# Revised proposed head house at 37 Beacon Street

Owners: Robert Coffin & Rebecca Dietrich

Architect: Josh Slater

# Requested information - Dimensions

VERTICAL SECTIONS

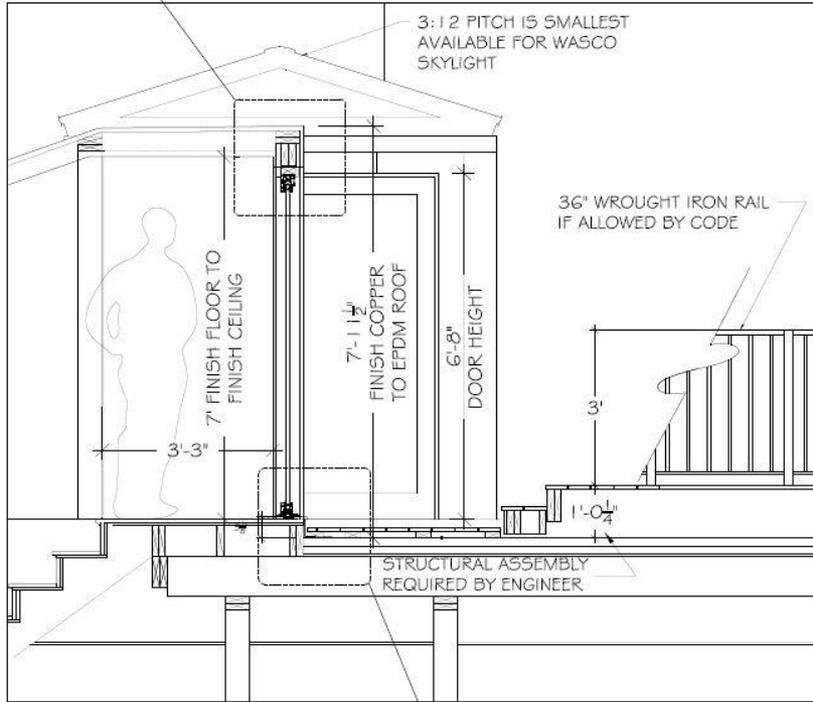
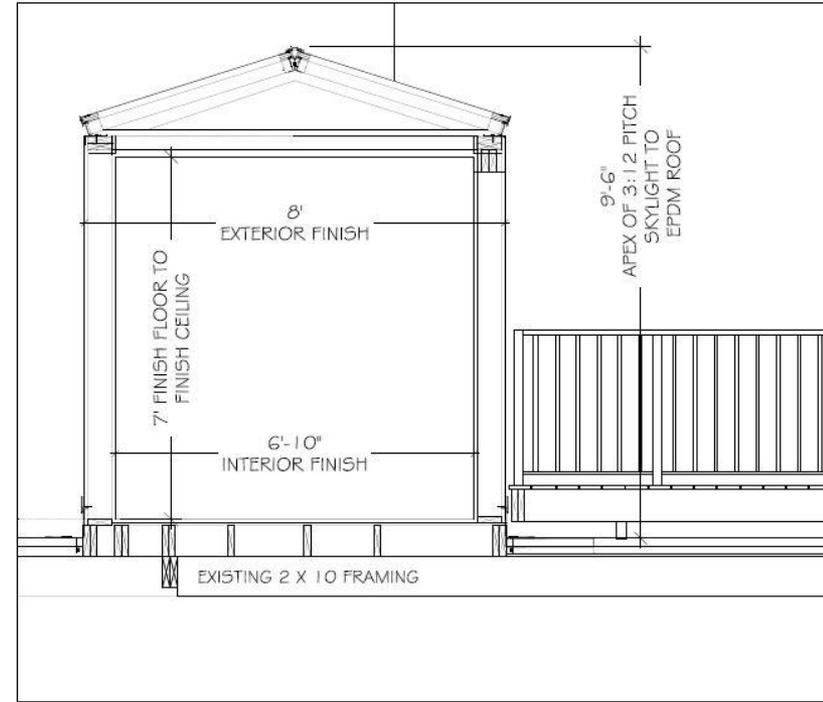
1. Height of the deck above the current EPDM membrane
  1. The deck surface is 12 1/4" above the current roof – this is the minimum which is possible from an engineering perspective

2. The railings will be 36" in height (if allowed by code)
  3. The top of the railings will therefore be 48 1/4" above the EPDM membrane (this compares to 64" for the railings for the current common roof deck)

2. Height of the door sills off the current roof, size of the doors to be used, and resulting roofline height
  1. The door sill is 5 1/8" off the current membrane

2. The doors are 6'8", the minimum required by code (5311.4.2)
  3. Including the structural header above the doors and the flat (minimum slope for water runoff) roof, the roofline is 7' 11 1/4", which is the minimum possible to meet code

**6**  
FROM A4.2  
DOOR/DUCKBOARD DETAIL

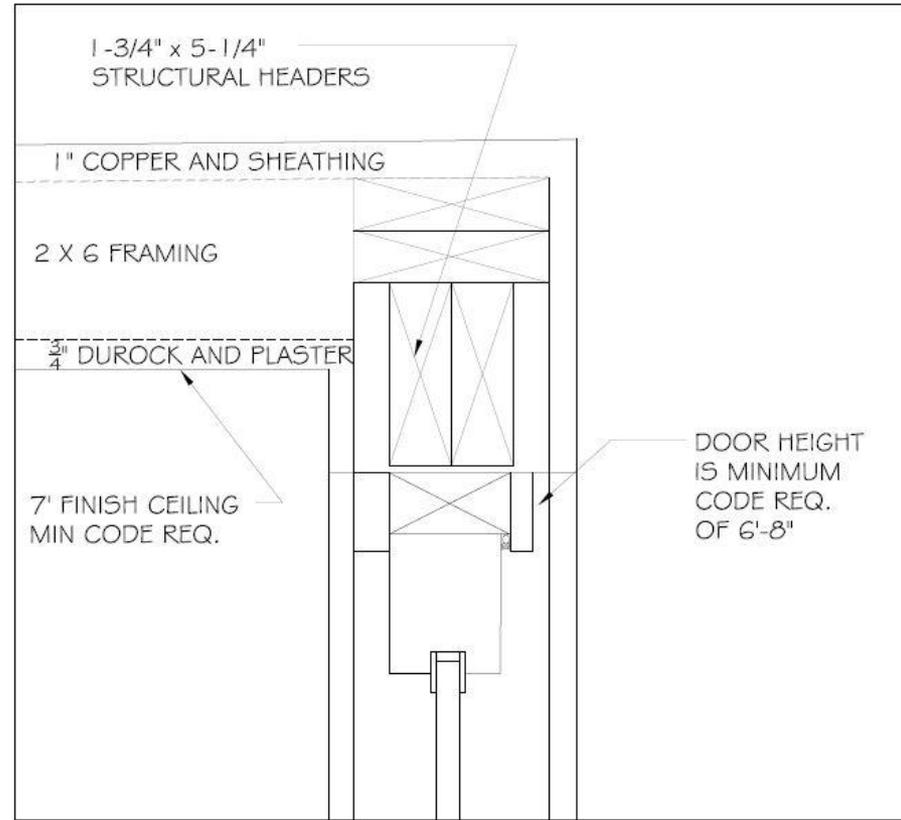
4. To keep height to a minimum, the door opens onto duckboard on the current roof membrane, the surface of which is 2 1/2" above the membrane. There are then two steps up onto the deck.

RAILING AND DECK DETAIL

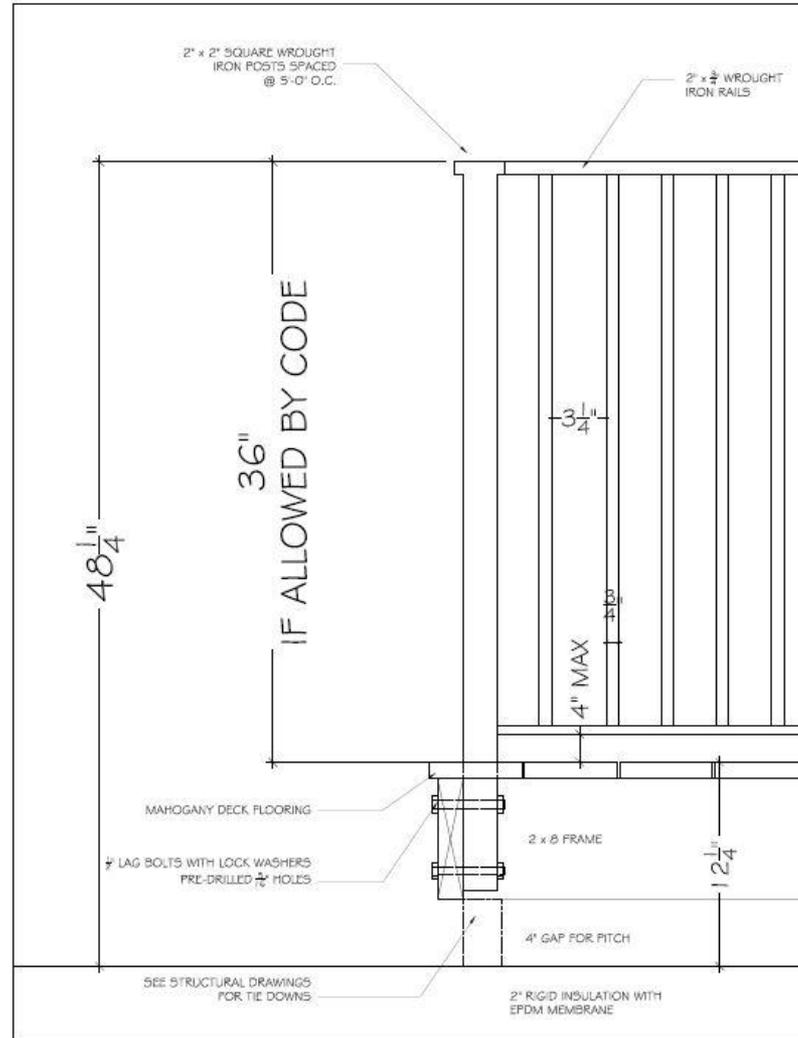
4. Design of the railings
  - It was agreed that these would be 36" (if allowed by code) & simple wrought iron

**[Red Shaded Area]** = INDICATES NOT VISIBLE FROM ANY PUBLIC SPACE

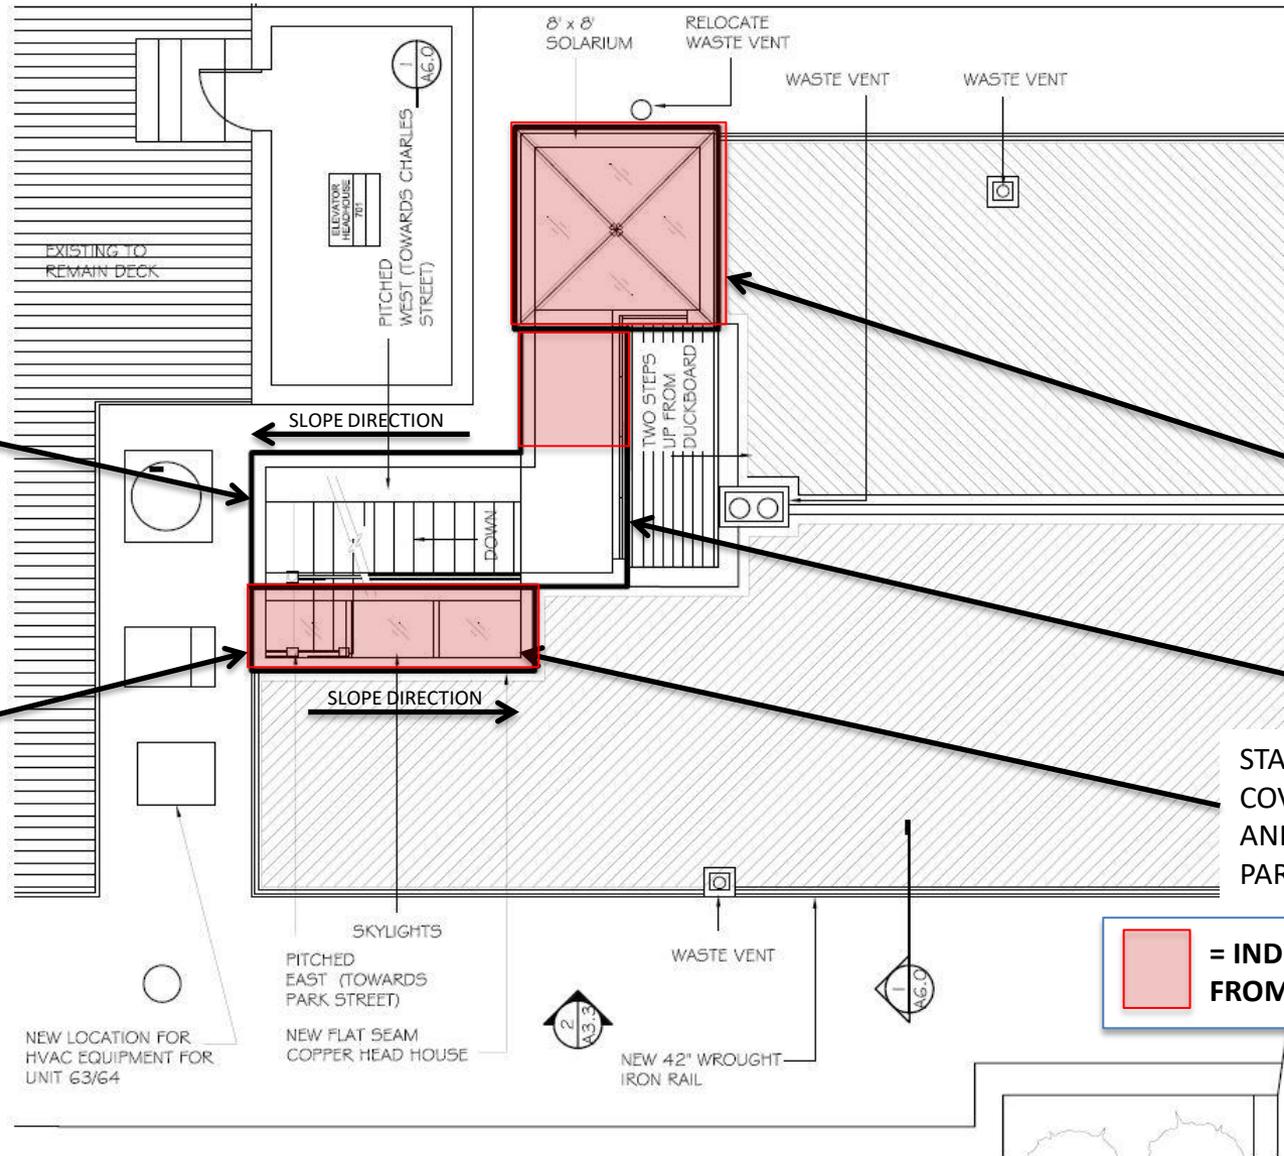
- The revised structure is also far less visible from any public space (i.e. only at a considerable distance from certain vantage points on the Common)

- The Applicants have determined that it is not possible to reduce the visible portions of the headhouse further while still allowing roof access through a door, with a small landing

- The minimally visible parts of the headhouse & railings can only be seen from a considerable distance from certain vantage points on the Common
- The design is such that impact is minimized, and architecturally compatible with Beacon Hill (although 37 Beacon St itself is not of particular historical interest, having been built in 1940)
